From: Lein, Jerry R.
Sent: Monday, August 24, 2009 4:51 PM
To: 'Kevin Solie'
Cc: Duey Marthaller; Hamre, John G.
Subject: RE: Belfield to Rhame structure move, Case No. PU-07-169
Attachments: Area_06_6.pdf

58 **PU-07-169** Filed: 8/24/2009 Pages: 2
Email – Staff Approval of Structure #106 Relocation

Area 6

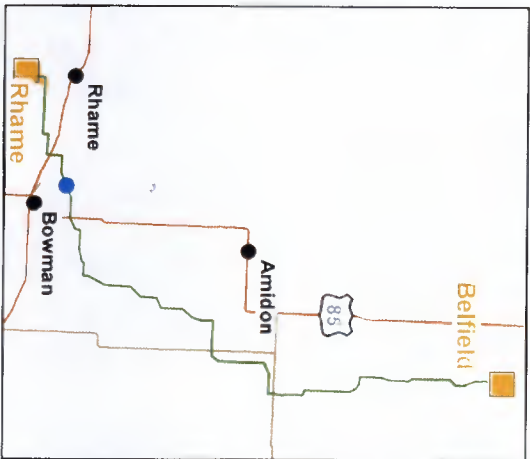
Basin Electric is requesting PSC concurrence to move structure #106 on the Belfield to Rhame Transmission line. As depicted on the attached map, the structure would be moved approximately 35' to the NE and would stay on the permitted route centerline. The purpose of the move is to put more distance between the structure and a wet area (which is unusually large this year). The landowner (Dorothy Eldringhoff) has been contacted regarding the structure #106 move and concurs with the proposed relocation.

Please consider this e-mail as staff approval of Basin Electric's requested structure #106 movement.
